UT to Mill Swamp Restoration Project Eighth Monitoring Measurement Seventh Year of Credit Release - Final

NCDMS Project ID Number – 95019, DEQ Contract No. 003992

Subject: Response Letter to DMS review comments regarding the Draft Year 7 Monitoring Report for the UT to Mill Swamp Restoration Project (#95019)
White Oak River Basin – CU#03030001, Onslow County, North Carolina
DEQ Contract No. 003992, Baker No. 124578

Figure 2A
Current Condition Plan View
Monitoring Year 7
UT to Mill Swamp Site

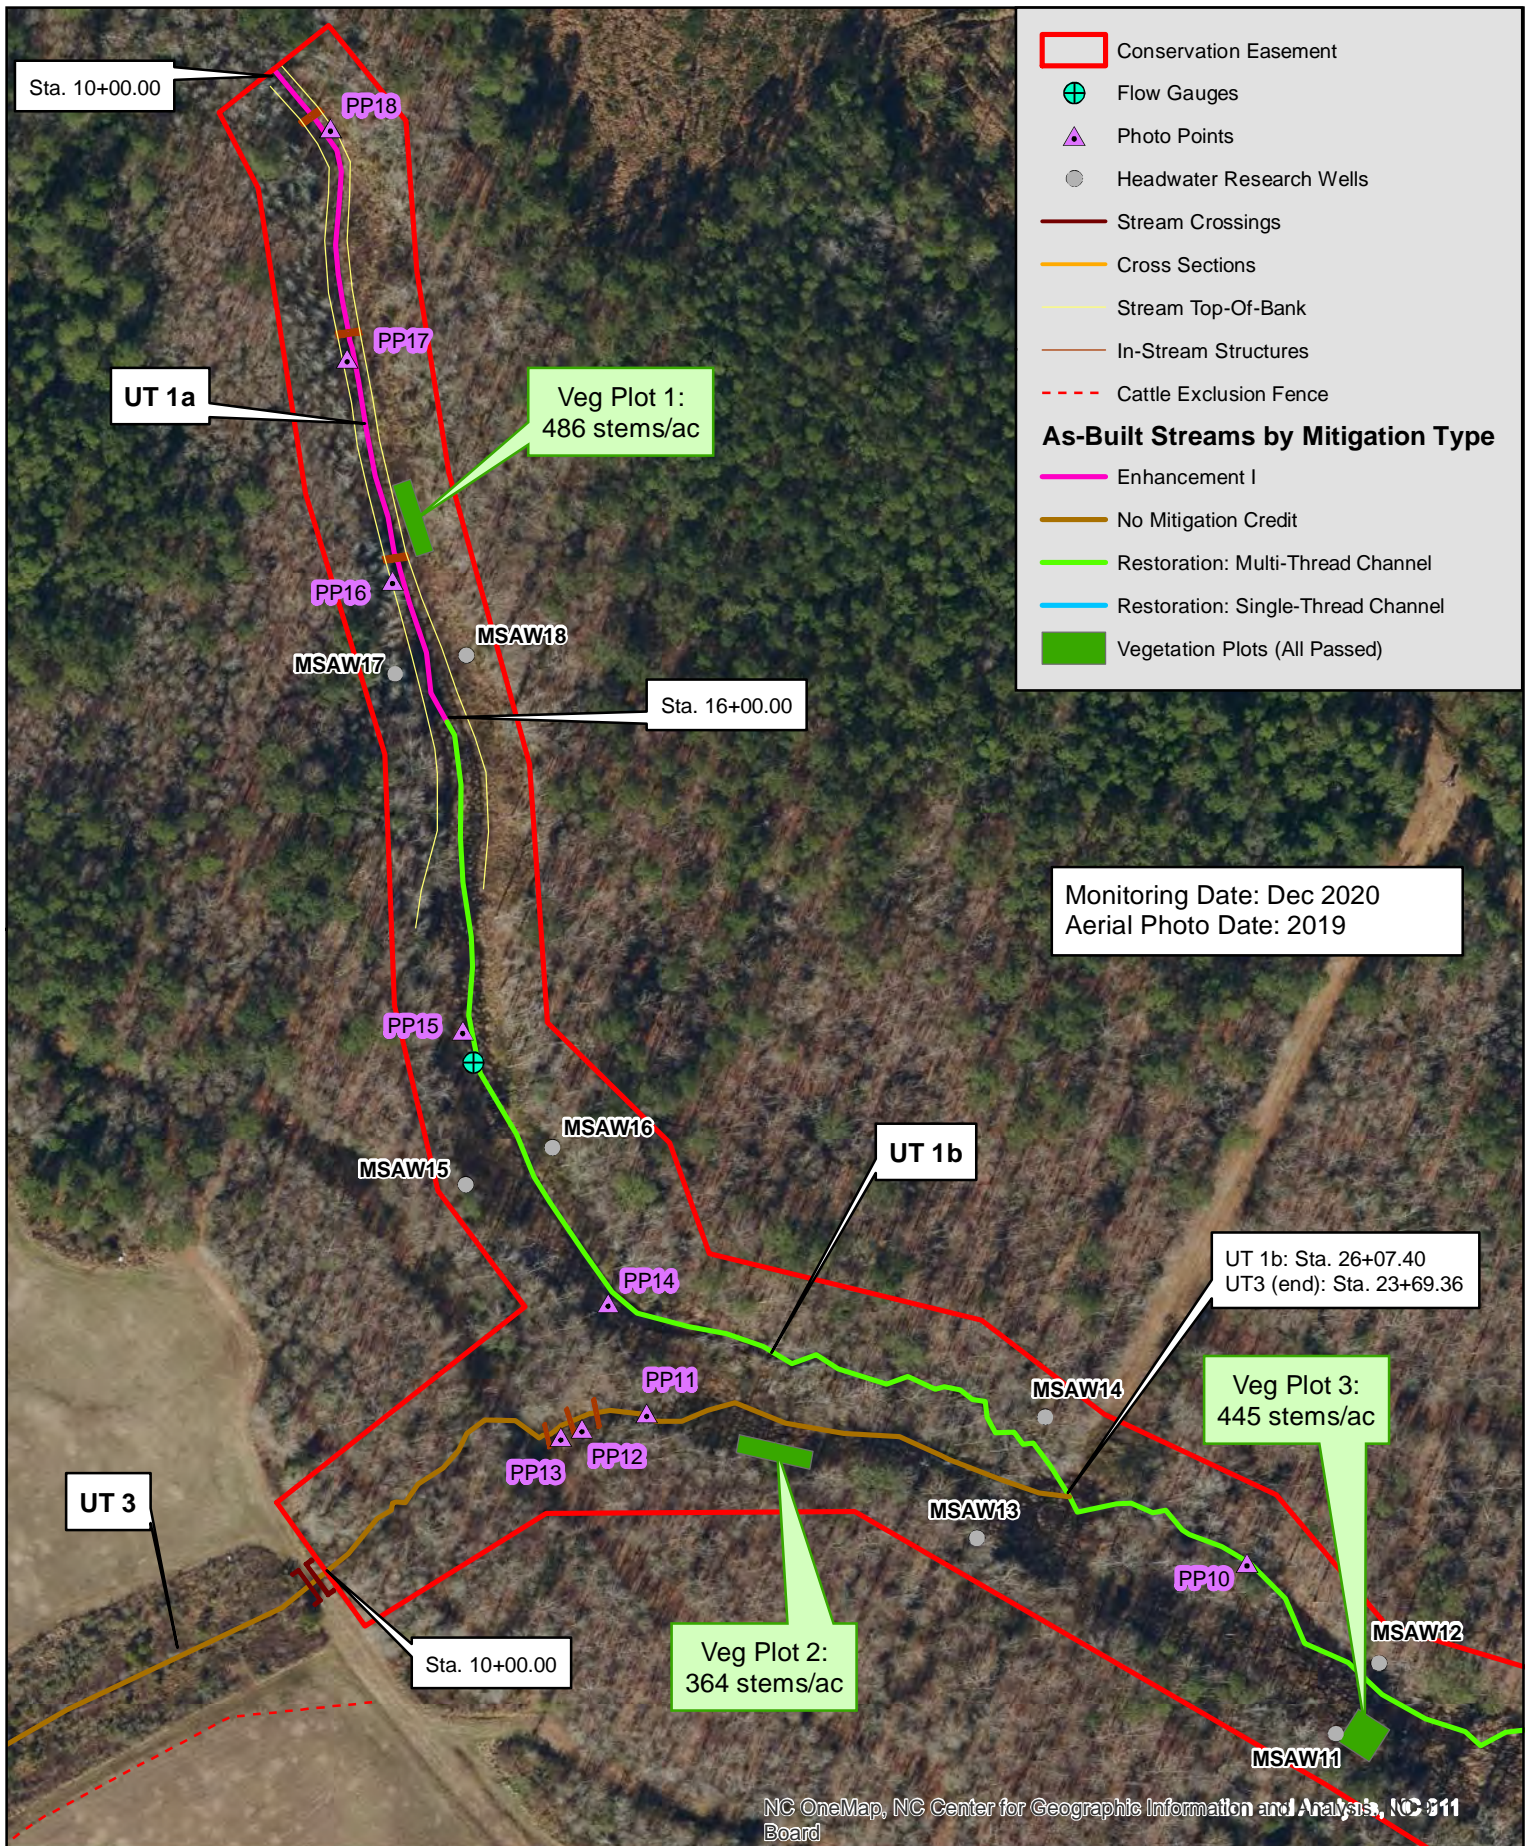
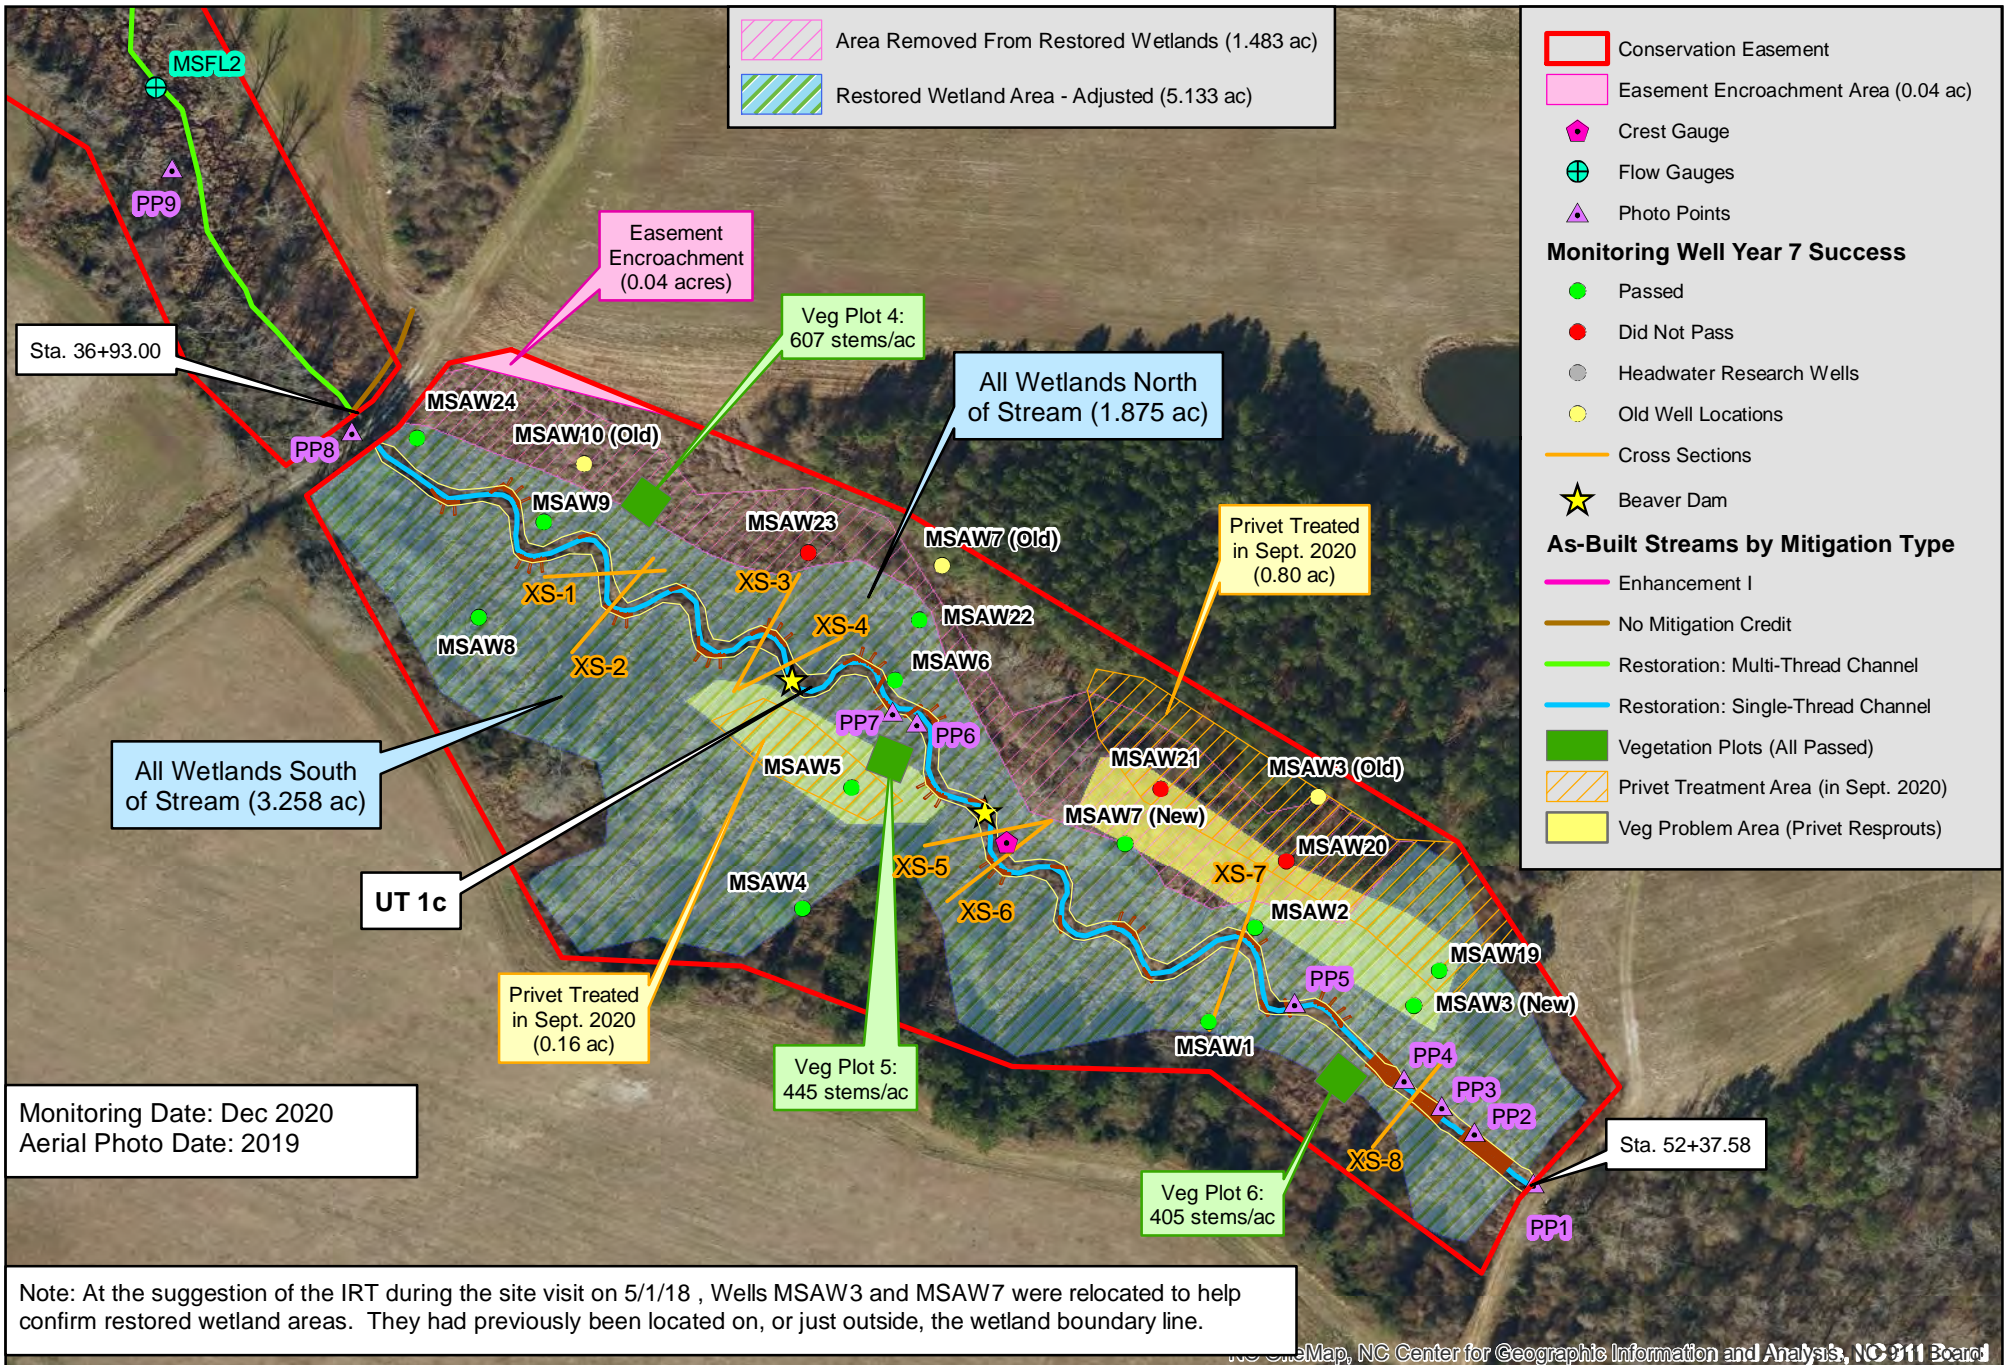
1. Appendix B
 - a. Figures 2 & 2B: Please show the new wetland boundary/area proposed to be removed from credit and adjust (or remove) the restored wetland acreage amount in the Legend.
Response: Figures revised as requested.
 - b. Recommend adding reach (UT1a) to text under photo points 16, 17, & 18.
Response: Revision made as requested.
2. Electronic Files
 - a. Please submit monitoring photos as JPEGs.
Response: Photographs provided as JPEGs in the revised digital files as requested.
